## REGULATORY INFORMATION DISTRIBUTION SYSTEM (RIDS)

SUBJECT: Forwards addl info re spent fuel pool reracking Amend  
 Applications 78 & 84, per 890328 & 29 telcons.

Subject: Docket Nos. 50-361 and 50-362  
Spent Fuel Pool Reracking  
Amendment Application Nos. 78 and 64 (PCN-287)  
San Onofre Nuclear Generating Station  
Units 2 and 3

REVISION 1 TO SPENT FUEL POOL RERACKING LICENSE AMENDMENT APPLICATIONS  
SAN ONOFRE NUCLEAR GENERATING STATION  
UNITS 2 AND 3

SAN ONOFRE NUCLEAR GENERATING STATION Units 2 & 3
RACK LOCATION IN SPENT FUEL POOL
FIGURE 2.2-3

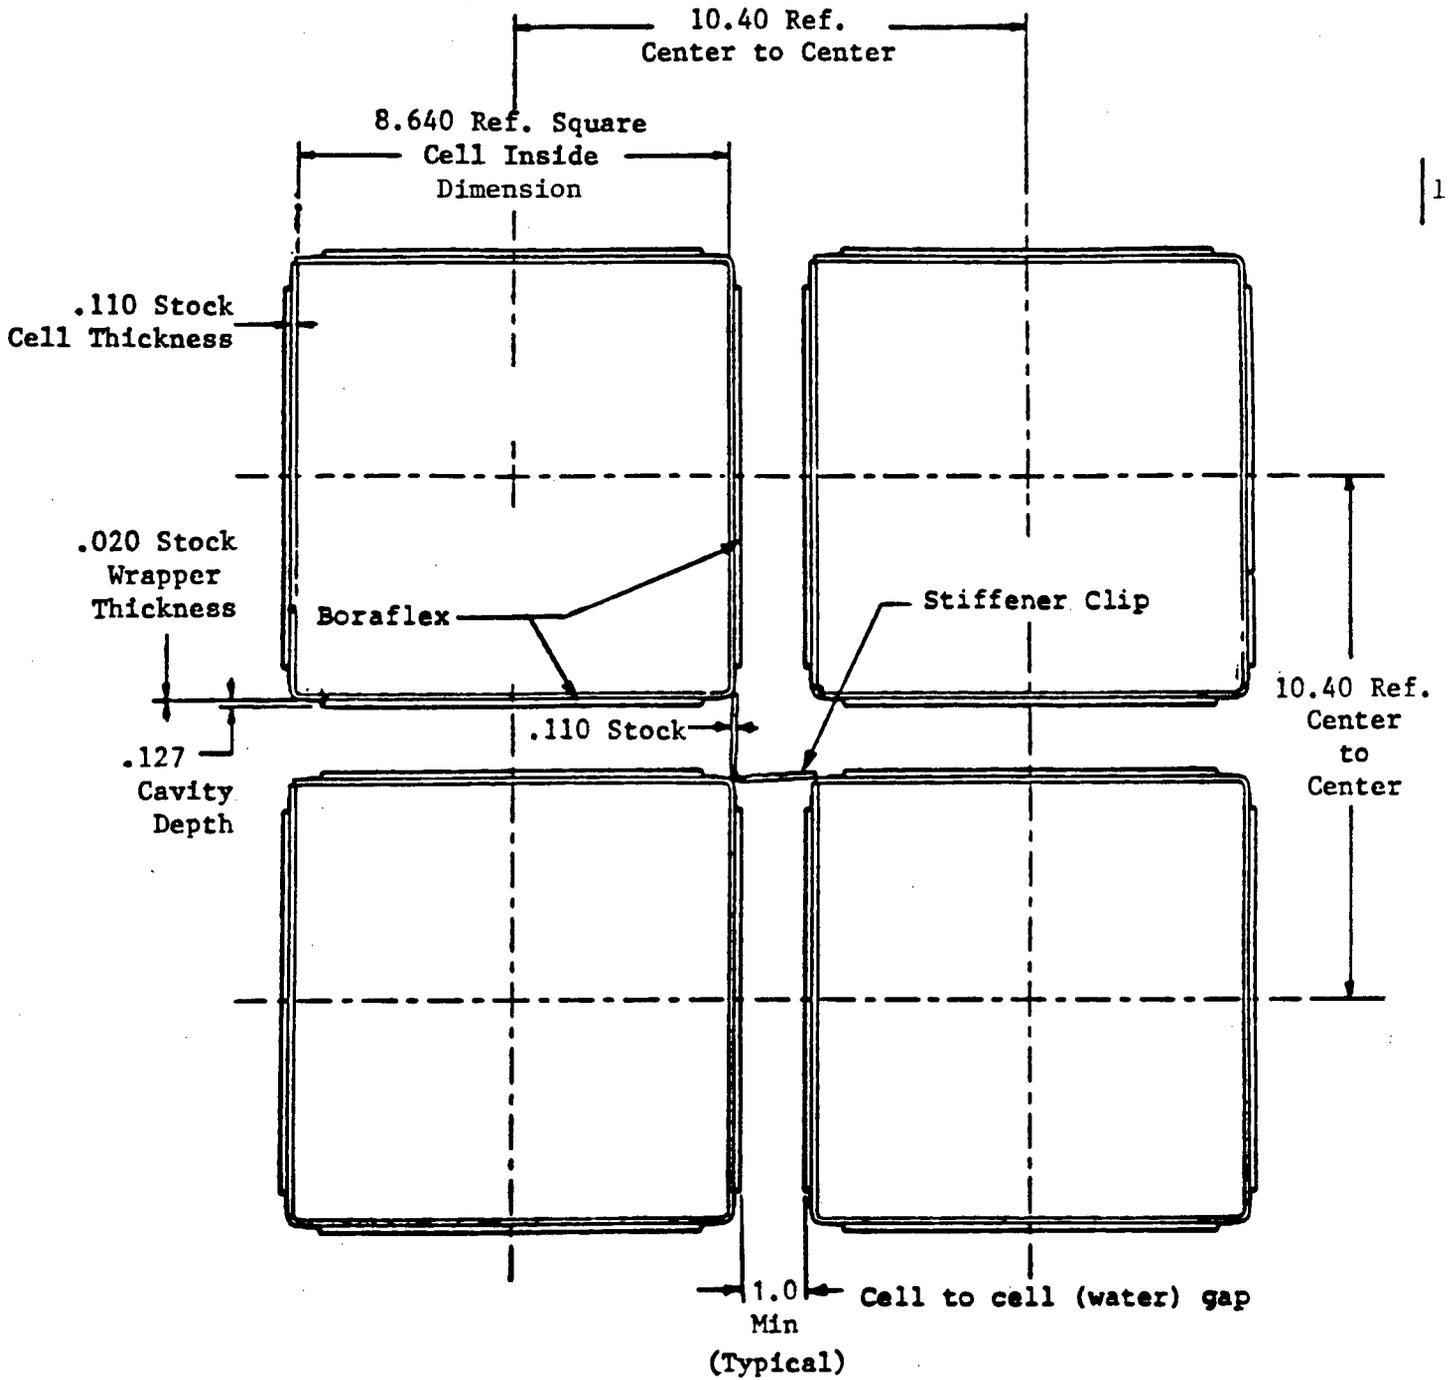
1. Figure 2.2-3 - Corrected top of racks height of 16 feet 6 1/2 inches to 16 feet 4 inches.
2. Page 4.6-13 - Corrected typographical error to include load combination 5.
3. Page 4.6-13 - Paragraph revised to provide clarification on the inclusion of load combination 5 in consideration of the limiting case.
4. Page 4.6-15 - Added formula for load combination 5 for use as limiting case. Deleted redundant note regarding dead loads and live loads.
5. Page 4.6-16 - Corrected seismic impact load at the grid spacer from 2110 pounds to 2142 pounds.
6. Page 4.6-20 - Added reference to Figure 4.6-10 for clarification.
7. Page 4.6-24 - Correct maximum drop weight to maximum drop height.
8. Page 4.6-25 - Text revised to clearly identify the spent fuel rack installation tolerance of 0.25 inches.

<b>SAN ONOFRE NUCLEAR GENERATING STATION Units 2 &amp; 3</b>
<b>REGION I CELL LAYOUT</b>
<b>FIGURE 3.1-1</b>

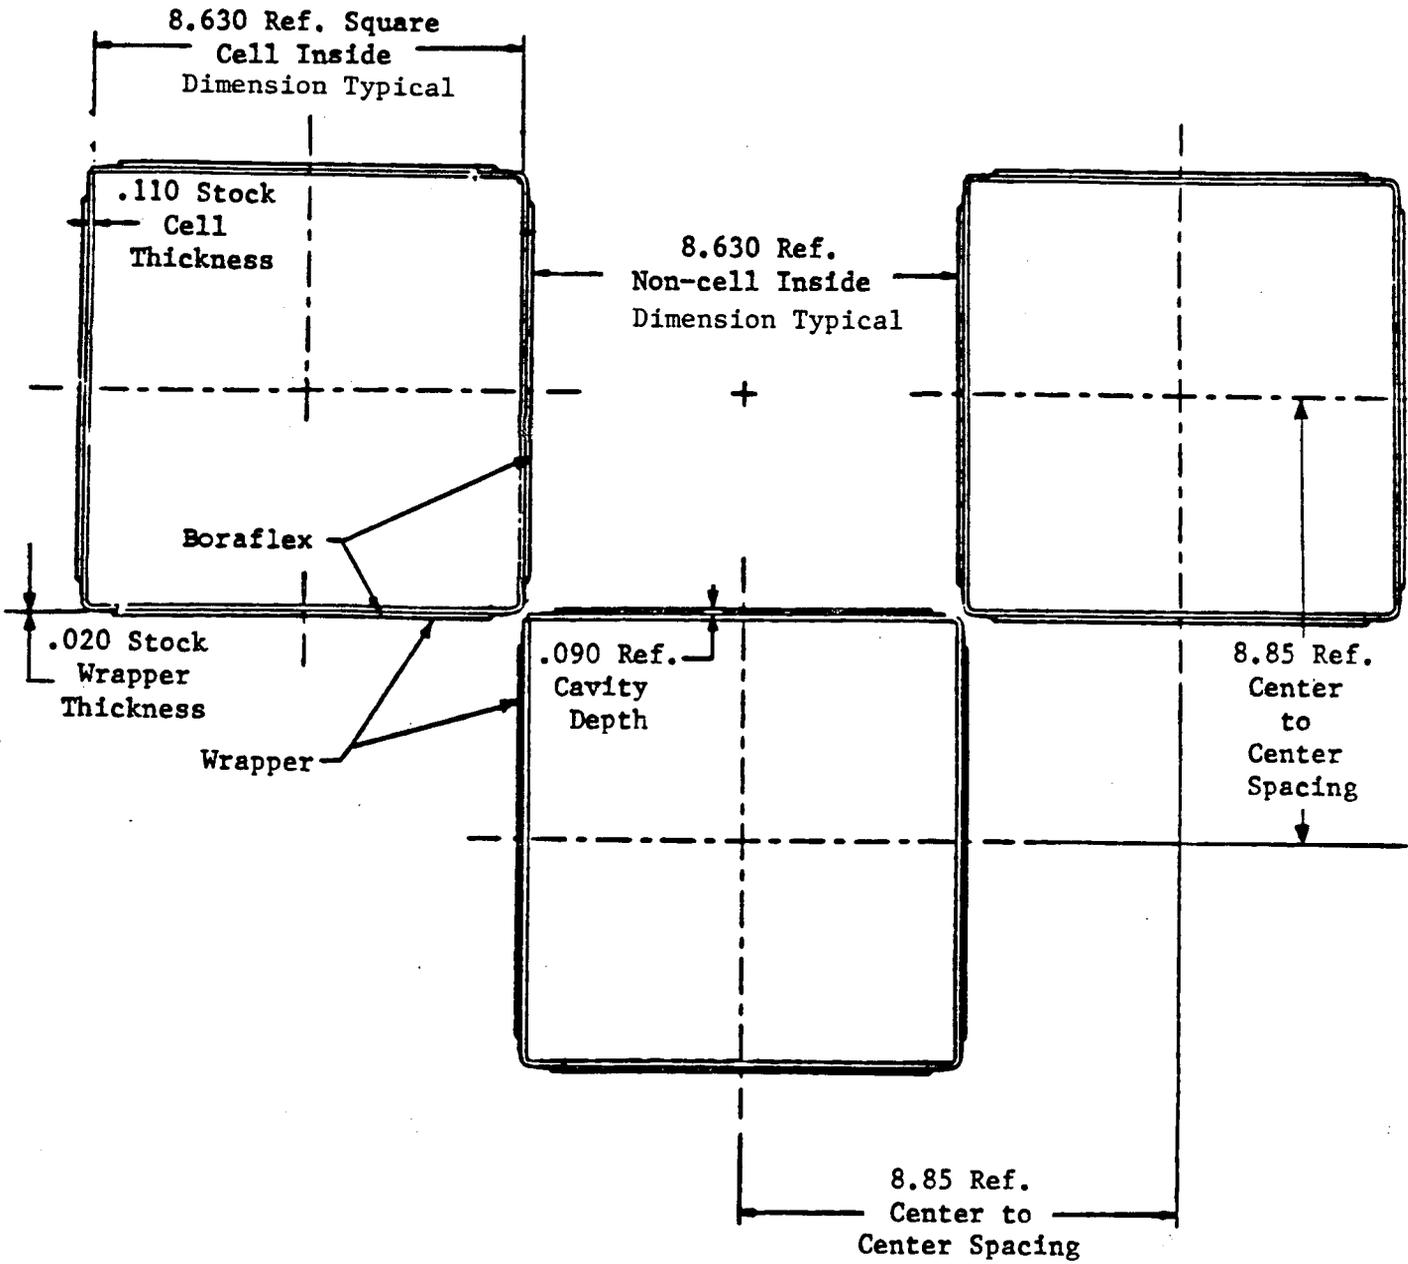
The Boraflex wrapper which positions the Boraflex on the side of a rack storage cell is made of Type 304 LN stainless steel, which is the same material as the racks. (See Sections 4.1.2.1.1, 4.1.2.1.2 and 4.7.1 of the "Spent Fuel Pool Reracking Report" March 1989 - Attachment E to the License Amendment Application Description and Safety Analysis.) The wrapper thickness is 0.020 inch as identified in Figures 3.1-1 and 3.1-2 of the "Spent Fuel Pool Reracking Report."
